Subject: Exelon Nuclear Texas Holdings, LLC
Victoria County Station
Response to Request for Additional Information Letter No. 01
NRC Docket No. 52-042

Response to NRC RAI Letter No. 01

RAI Question 02.05.01-1

Figure 1: Profiles 4 through 8 from SSAR Figures 2.5.1-50b and 2.5.1-50c shown with no vertical exaggeration (i.e., 1:1 horizontal to vertical scale). Zones of potential deformation indicated in this figure are the same as in the original SSAR figures.

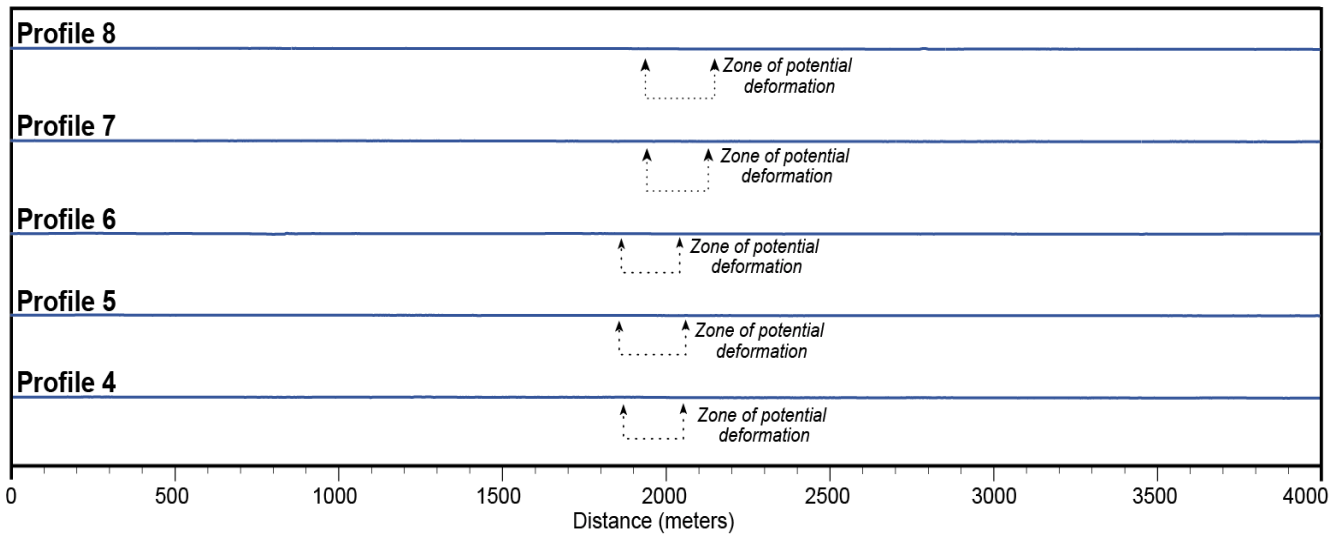
The variation in topography is so minor across the zone of surface deformation associated with both growth faults D and E (Figure 1) that the soils on the deformed surface would not be subjected to different rates or styles of soil-forming processes. Because different rates or styles are necessary to form a soil catena, variations in soil characteristics across the zone are not expected. The age of soil horizons on the tilted land surface are also not thought to be able to constrain the timing of deformation associated with the growth faults, because soil development is not likely to have been impacted by the formation of the subtle monoclinial folding or tilting (e.g., steepest slopes of < 0.5°). However, an analysis of soil maps for the site area (Miller 1982; USDA 2010) is described below.

As discussed above, there is no observed fault scarp associated with either growth fault D or E. Instead, the faults are associated with broad, low-amplitude, monoclinical folding and/or tilting (Figure 1). As such, it is not appropriate or feasible to use diffusion dating, a method premised on the rate of erosional degradation of a scarp formed by discrete surface fault rupture, to estimate the age of the surface deformation. The primary reasons why diffusion dating and other methods cited in the reference provided in the RAI question (McCalpin 2009) are not appropriate include:

As a point of clarification, the topographic profiles presented within the SSAR (SSAR Figures 2.5.1-48 and 2.5.1-50) are shown on plots with 100 to 200 times vertical exaggeration, and thus the broad monoclinial folding and tilting appear as abrupt changes in surface topography similar to erosionally modified fault scarps. However, when the same profiles are presented without any vertical exaggeration (Figure 1), the folding is not visibly discernable. When discussing the deformation associated with growth faults D and E, the profiles shown in the SSAR can be used to more easily identify the zone of deformation and assess its location and dimensions. However, the profiles presented in Figure 1 provide a more accurate representation of the true style of surface deformation above the buried growth faults.

- There is no fault scarp. The topographic relief on the Beaumont surface above the growth faults was produced by long-wavelength tilting or folding, not erosion of a surface fault scarp, thus violating the key premise of the diffusion dating technique;
- The slope of the monoclinical folding and tilting is less than 0.5° , and is thus very gentle and not appropriate for the linear-plus-cubic diffusion method; and
- There are no reliable estimates of the diffusion constant for the type of Pleistocene sediments that comprise the Beaumont Formation and the climate of southern Texas; thus, it would not be possible to obtain reliable age estimates from the diffusion dating technique even if the Beaumont surface was deformed by discrete surface faulting.

Figure 2.5.1-4 Site Area Geologic Map (5-Mile Radius)

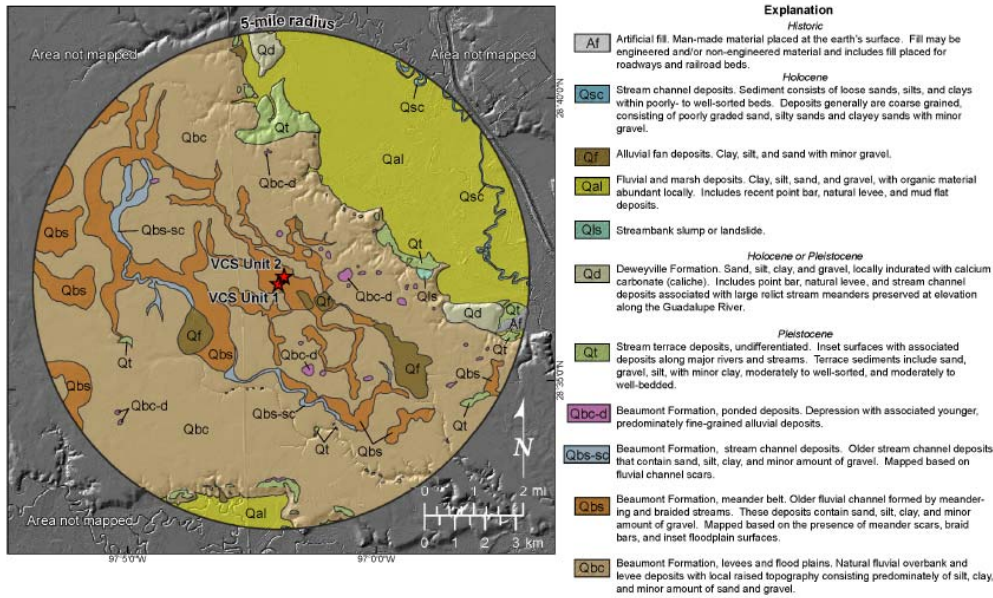
At the southern end of the site area, the surface deformation associated with growth fault E extends into floodplain deposits of the San Antonio River (SSAR Figure 2.5.1-4 and 2.5.1-39). The floodplain surface is inset (topographically lower and younger) into the Beaumont Formation surface. Based on the NCRS soils map, the soils developed in the floodplain deposits are interpreted to be Holocene in age (USDA 2010). However, the site area geologic map included in the SSAR (SSAR Figure 2.5.1-4) incorrectly indicates that some of these deposits are of the Beaumont formation (i.e., the Qt map unit at the southern boundary of the site area in the San Antonio river valley). The site area geologic map and associated text within the SSAR will be modified, as described in the enclosed SSAR markups, to indicate that this unit is Holocene in age (i.e., the map unit will be described as Qal instead of Qt).

SSAR Sections 2.5.1.2.4.2.3, 2.5.1.2.4.2.4, SSAR 2.5.1 References, and Figure 2.5.1-4 will be revised as follows:

SSAR Figure 2.5.1-4 will be replaced with the following revised Figure:
